STAFF RECOMMENDATION 2213 Grantland Avenue October 21, 2015

Application: New construction—addition; Outbuilding
District: Woodland in Waverly Historic Preservation Zoning Overlay
Council District: 17
Map and Parcel Number: 10514009500
Applicant: Preston Quirk, architect
Project Lead: Melissa Baldock, melissa.baldock@nashville.gov

Description of Project: Application is to construct an addition and an outbuilding.

Figure 1. 2213 Grantland Avenue

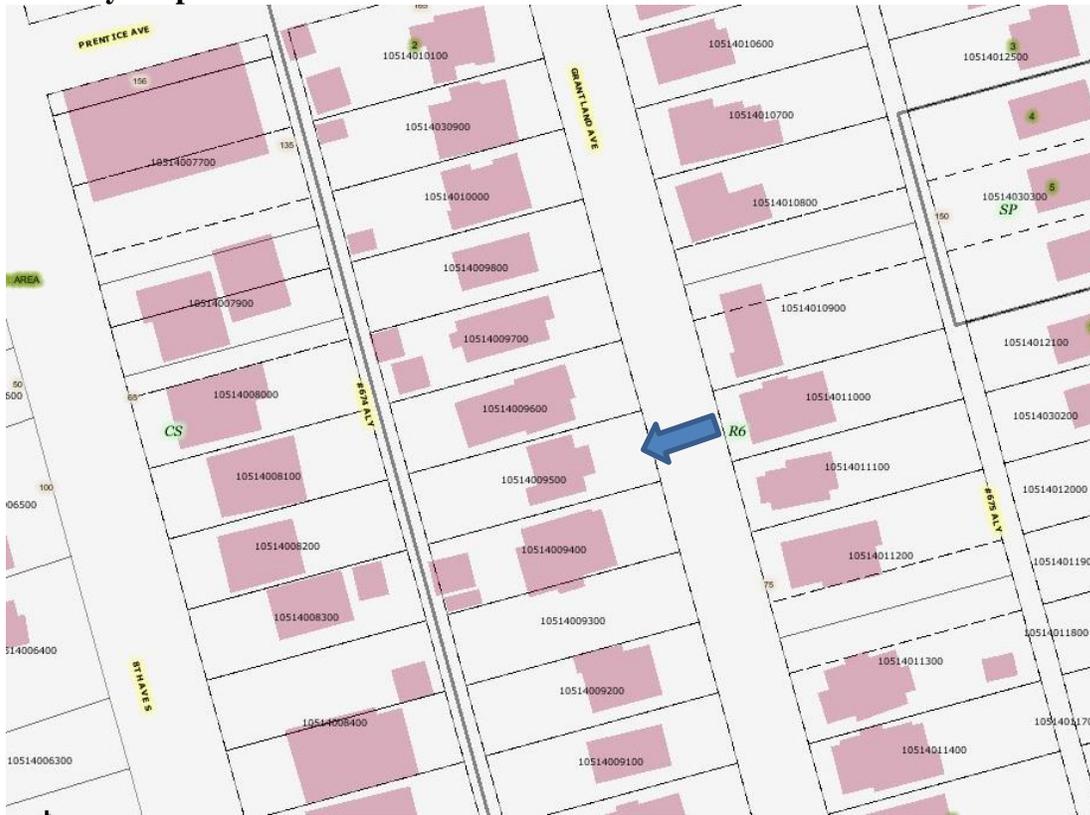
Background: 2213 Grantland Avenue is a c. 1930 brick bungalow that contributes to the Woodland-in-Waverly Historic Preservation Zoning Overlay (Figure 1).

Alterations to Historic House: The only change to the existing historic structure indicated on the plans is the addition of a simple hand rail on the front porch. The material for the hand rail was not indicated, and staff asks to approve the final material and design of the hand rail prior to purchase and installation to ensure that the change meets Section II.B.2. of the design guidelines.

Figure 2 (left) is a photo of the area to be demolished and Figure 3 (right) is the 1957 Sanborn Map that shows that this portion of the house was formerly a porch.

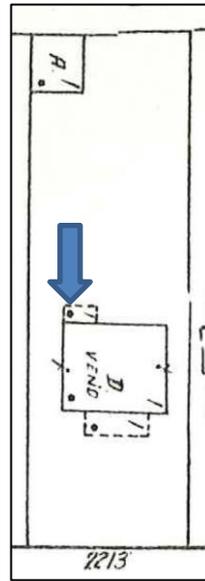
Partial Demolition: The applicant is proposing to demolish a portion of the rear of the house (Figure 2). The area to be demolished appears as an open porch on the 1957 Sanborn Map, but has since been enclosed (Figure 3). Staff finds that this portion of the house, with its lower hipped roof form, does not contribute to the overall historic character of the house and that its demolition would not significantly impact the house's

historic integrity. Staff therefore finds that the demolition of the rear portion of the house meets the design guidelines' Section V.B.2. for appropriate demolition and does not meet Section V.B.1. for inappropriate demolition.
